ADDENDUM NO. 4

PROJECT NAME: GSD – HPD 1200 Travis Parapet Demolition and Reconstruction

PROJECT NO: WBS No. G000212-0005-4-01-01

**Item 1:**

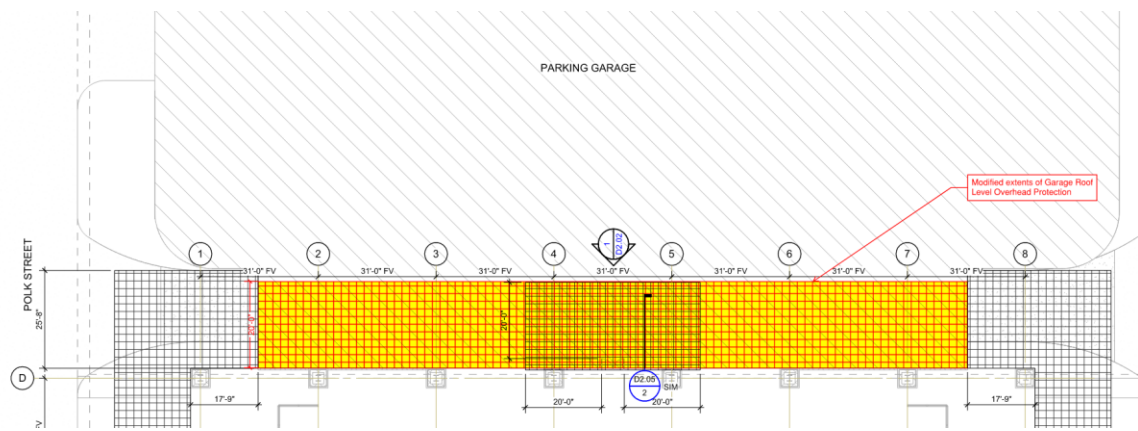
- Question No. 6: What is the existing fire alarm system manufacturer and type?
  - Notifier Alarm System NFS2 -30-30
- Question No. 7: Will overhead fall protection be allowed all the way across the parking spots on the top floor of the parking garage?

- WPM Response: Extent of overhead protection on Sheet D1.03 for the Roof Level of the garage is currently shown as projecting 20-feet from the face and 20-feet to either side of the access door. For bidding purposes, the extent of Garage Roof Level overhead protection shall be modified to run along the entire length of the parking garage aisles adjacent to the building as shown below:
  -
